Town of Medway
DESIGN REVIEW COMMITTEE
155 Village Street, Medway MA 02053
(508) 533-3291

DRC Meeting Minutes: June 04, 2018 Medway Public Library

Design Review for 9 Trotter Drive site plan for Converting Technical Services

WELCOME TO CHOATE PARK

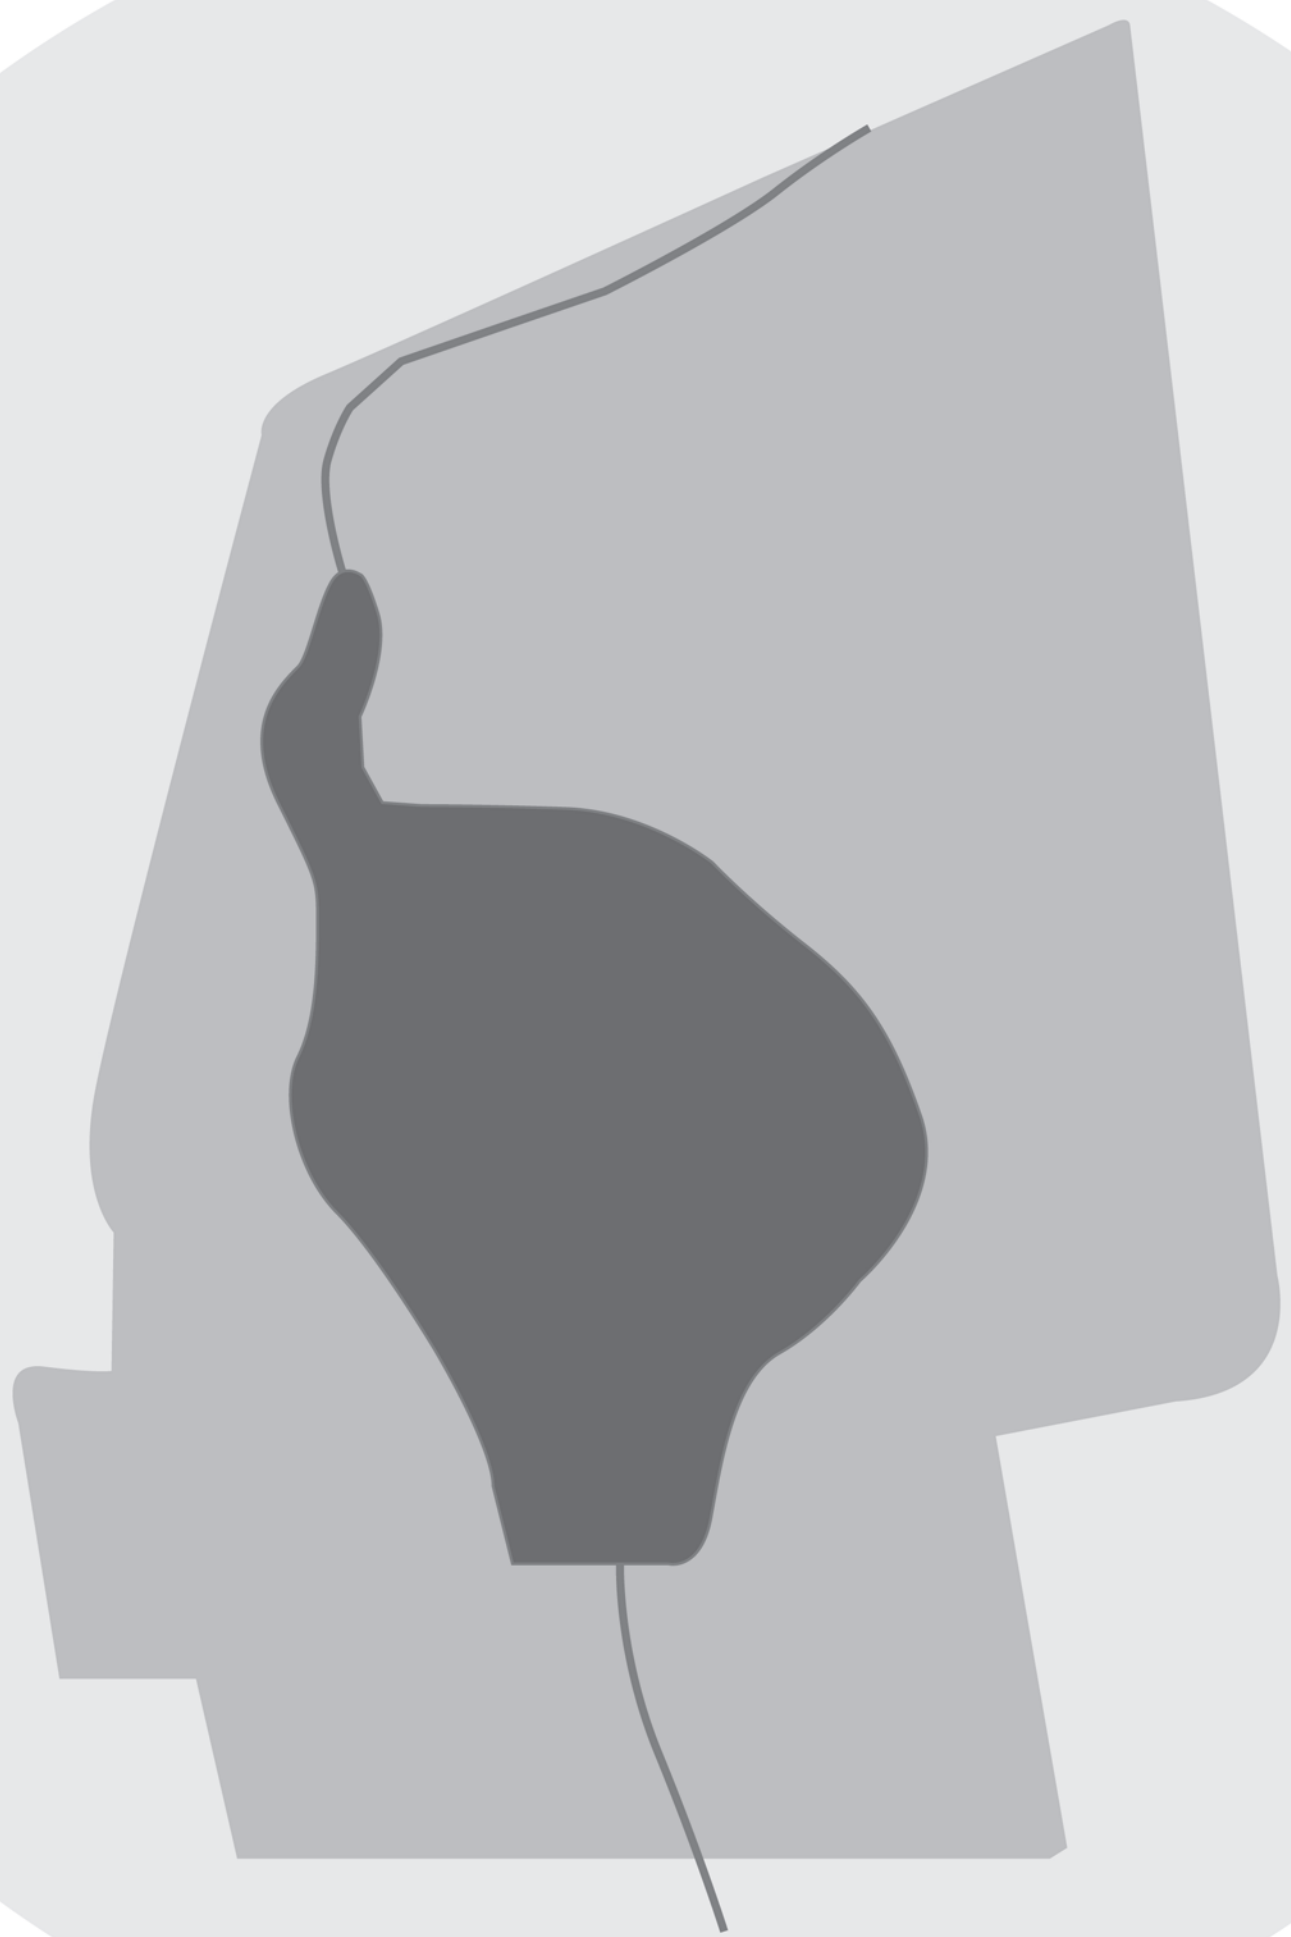
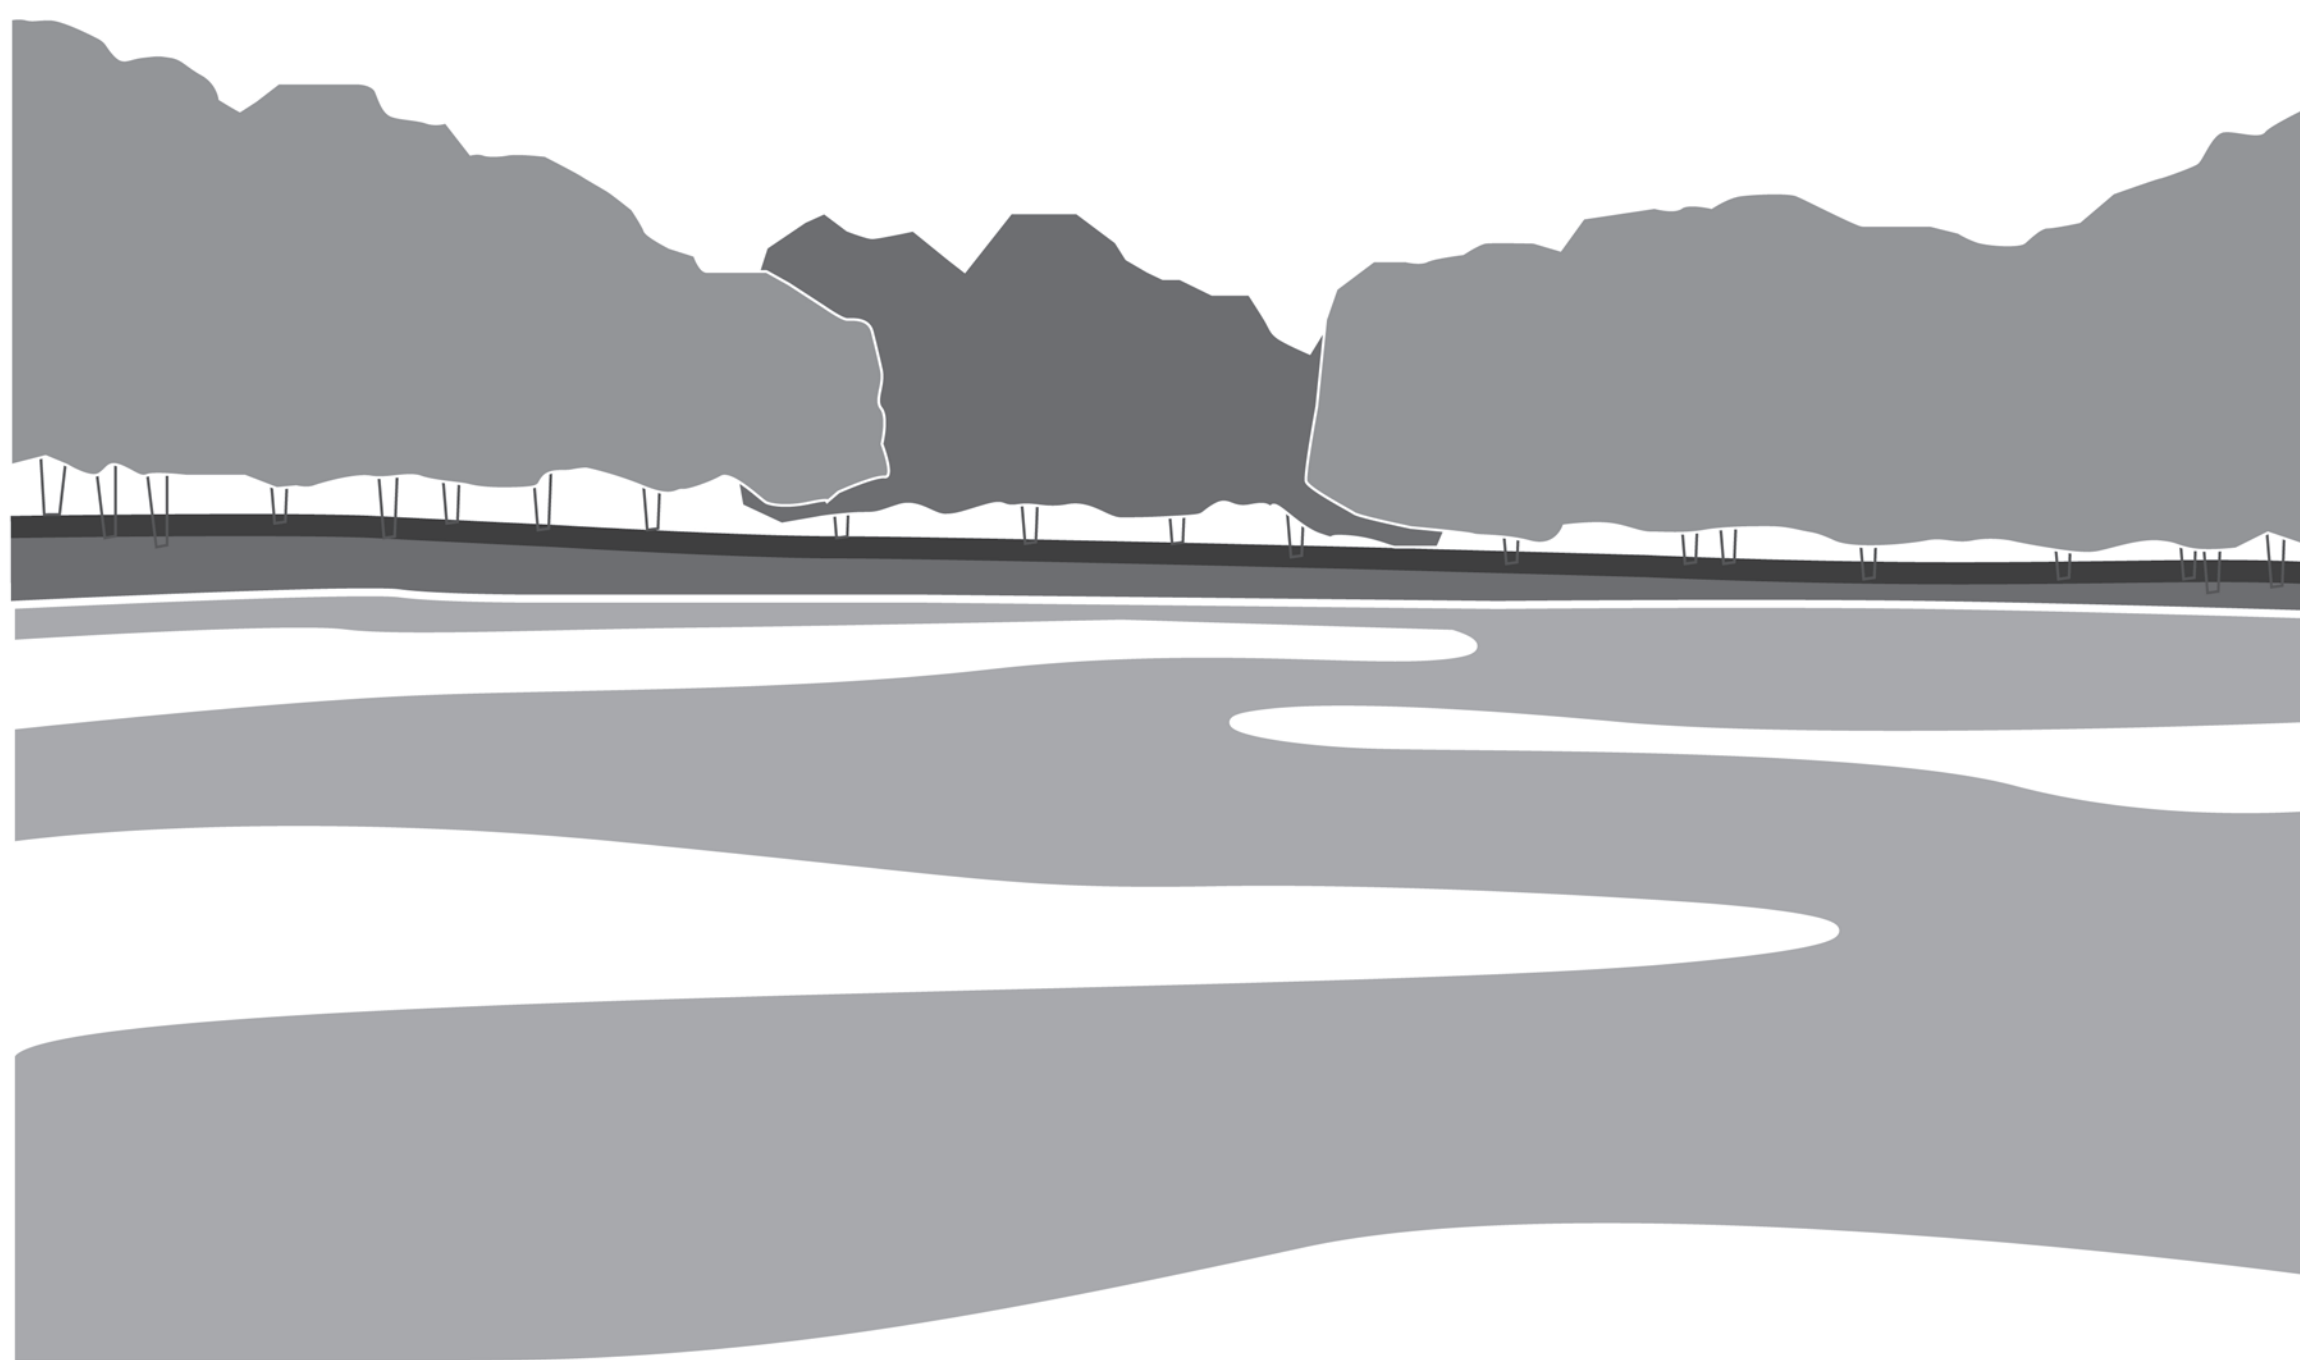
- ❖ Ms. Affleck-Childs distributed the granite bollard draft concepts submitted by DJ Chagnon from CBA. (**See Attached**) There was some discussion on the location of the way finding signs. Ms. Affleck-Childs said EPFRAC will be meeting on June 11th. Mr. Buckley will be reaching out to EPFRAC Chair Rick D’Innocenzo to discuss the location (s) of the way finding signs and the bollards. Perhaps the bollards can be eliminated as the community message board sign includes Choate Park inset signs.

- ❖ Way finding sign on the Cassidy side of Choate Park were discussed as an option.
- ❖ DRC members quickly reviewed the “Town of Medway” concepts shared by DJ Chagnon.
